SUNDRY NOTICES AND REPORTS ON WELLS
Do not use this form for proposals to drill or to re-enter an abandoned well. Use form 3160-3 (APD) for such proposals.

1. Type of Well <input type="checkbox"/> Oil Well <input checked="" type="checkbox"/> Gas Well <input type="checkbox"/> Other		8. Well Name and No. BLAST BLA FEDERAL 1
2. Name of Operator YATES PETROLEUM CORPORATION Contact: TINA HUERTA E-Mail: tinah@yatespetroleum.com		9. API Well No. 30-015-36136
3a. Address 105 SOUTH FOURTH STREET ARTESIA, NM 88210	3b. Phone No. (include area code) Ph: 575-748-4168 Fx: 575-748-4585	10. Field and Pool, or Exploratory WILDCAT; WOLFCAMP
4. Location of Well (Footage, Sec., T., R., M., or Survey Description) Sec 17 T26S R27E NWSE 1980FSL 1650FEL		11. County or Parish, and State EDDY COUNTY, NM

**Blast BLA Federal 1
30-015-36136
Yates Petroleum Corporation
May 07, 2013
Conditions of Approval**

WELL NAME: Blast "BLA" Federal No. 1 FIELD: _____

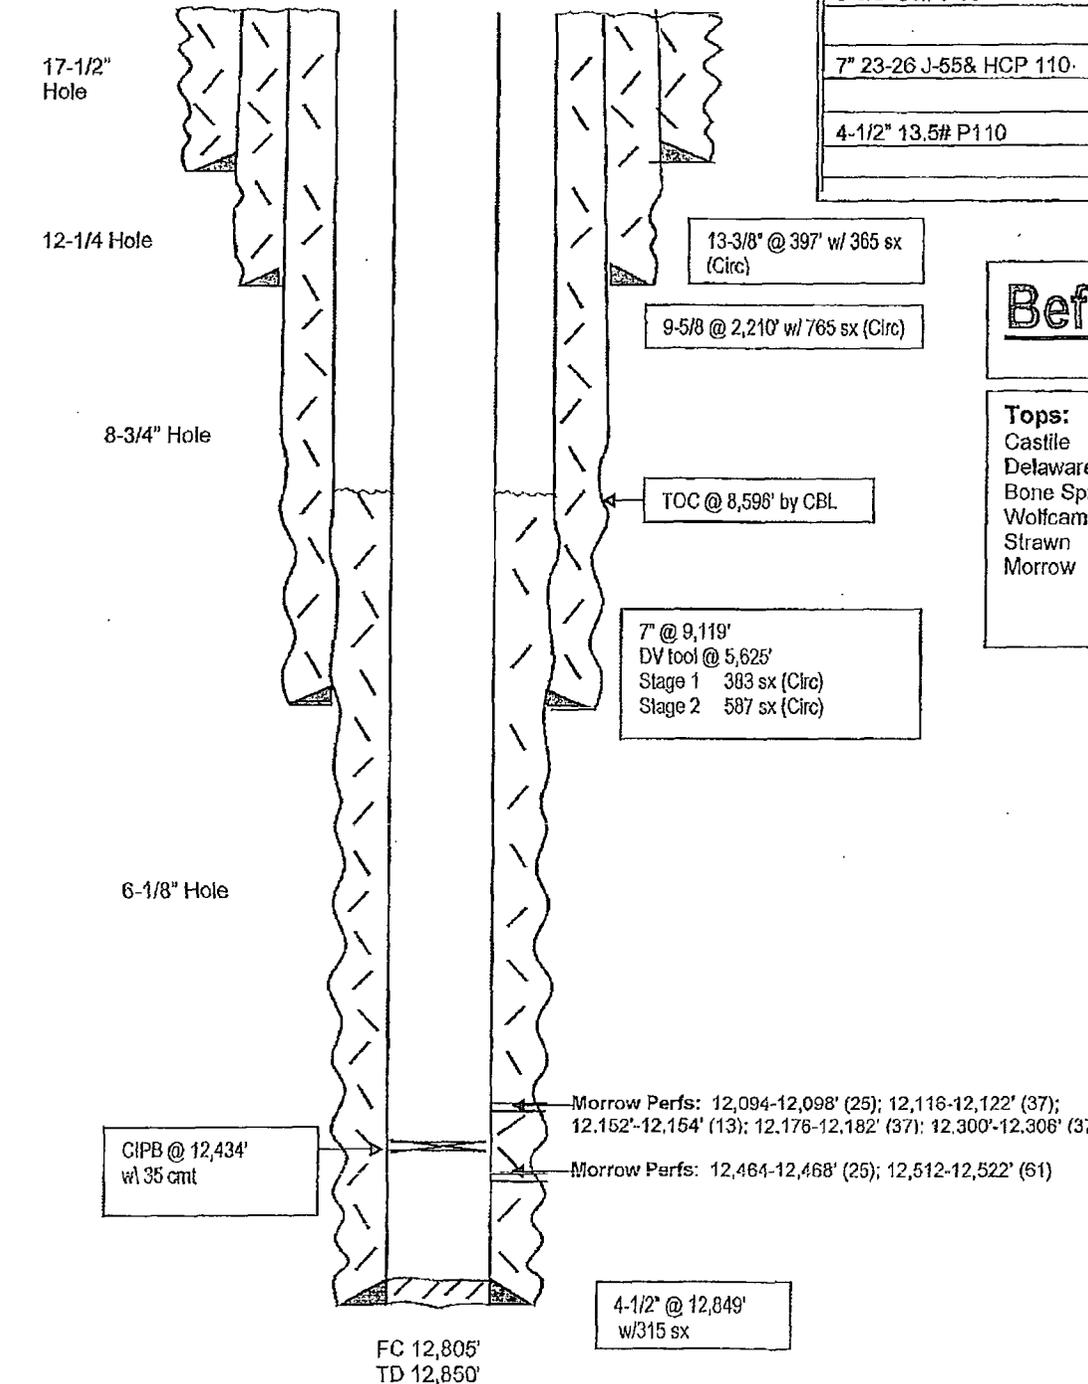
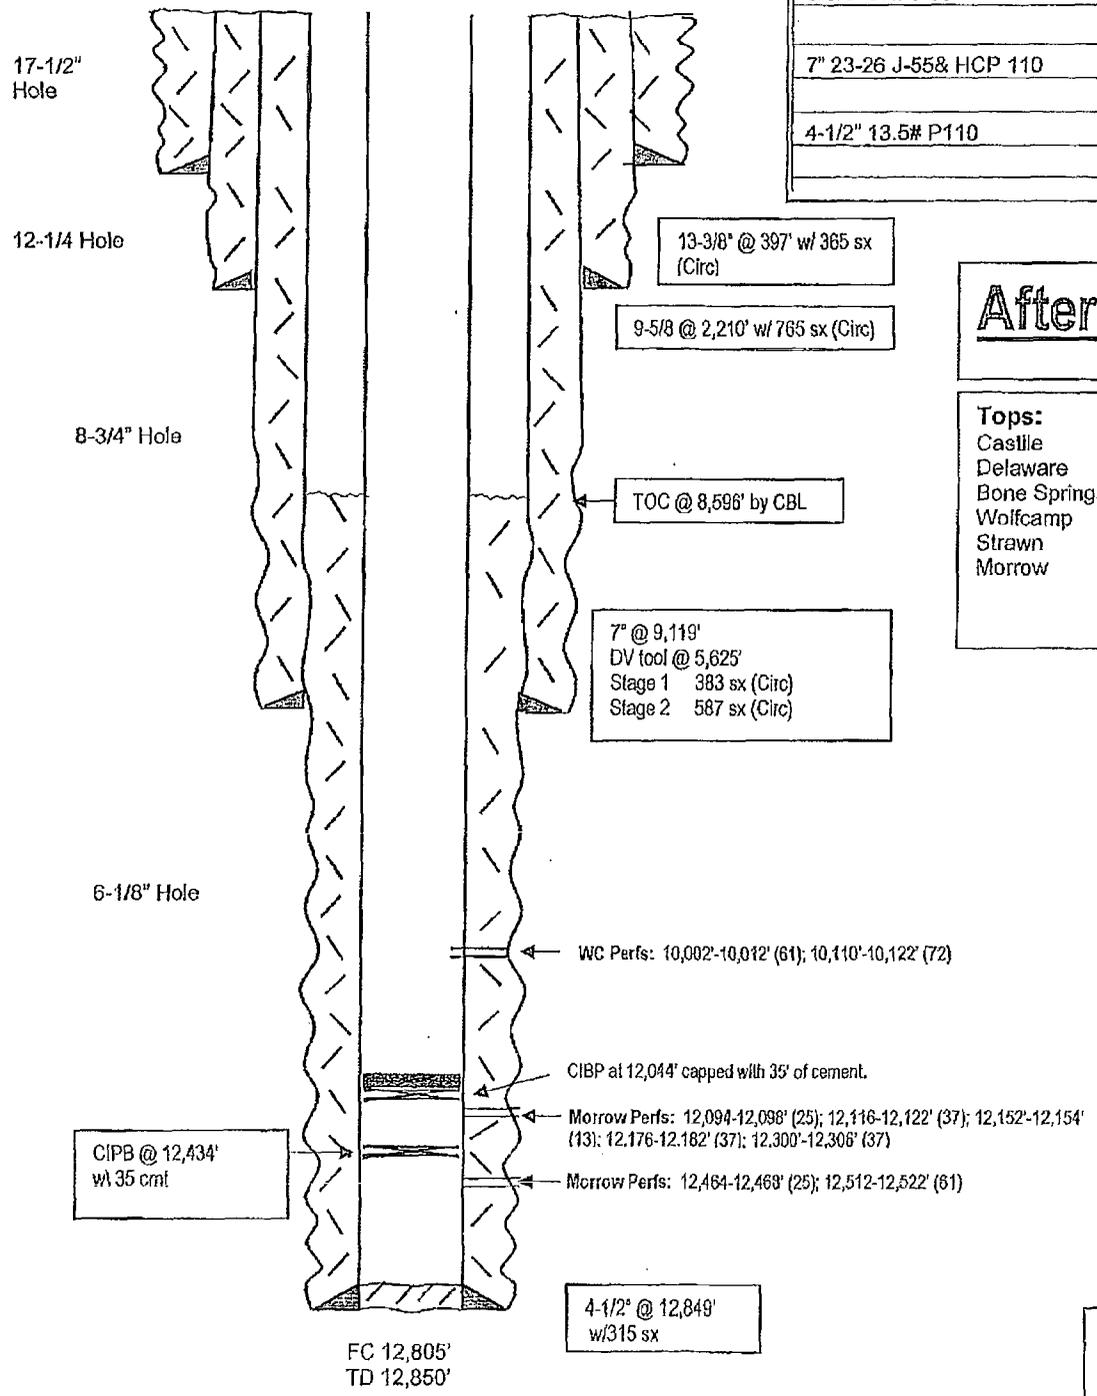
- MIRU any safety equipment as needed. NU BOP.
- Load hole as necessary with treated water to POOH with tubing and packer.
- Set a CIBP at 12,044 ft and cap with 35 ft of cement. Perforate Wolfcamp 10,002 ft - 10,122 ft (134).
- Set packer at 9752 ft. Swab test and evaluate.
- Pump 5000g 7-1/2 percent MSA with a nitrogen assist, 2000 scf/bbl. Drop 75 1.3 SG RCN ball sealers spaced out evenly throughout the acid. Flush to the bottom perf with treated water and N2.
- Flow well back until it cleans up.
- Turn well over to production.

- 1. Set CIBP at 12,044' and place a 220' plug of neat class H cement on top. Tag at approximately 11,824'.**
- 2. Must conduct a casing integrity test before any perforating can be done. Submit results to BLM. The CIT is to be performed on the production casing per Onshore Oil and Gas Order 2.III.B.1.h.**
